## Geologic Setting of North Trail Office Park

SPC-2023-0357C

## Our Appeal

### **Septic Systems**

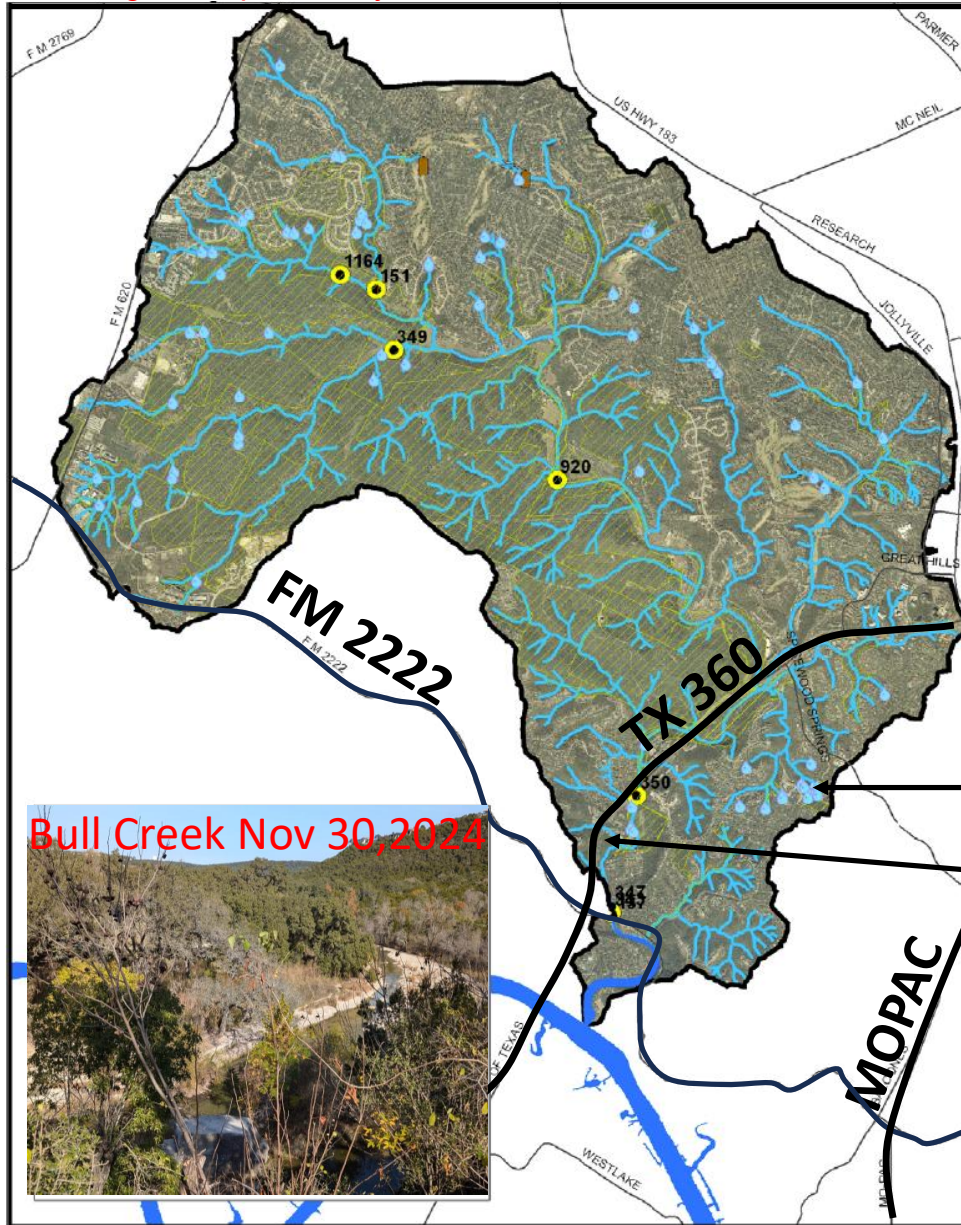
are part of the “Urban” sources of seeps
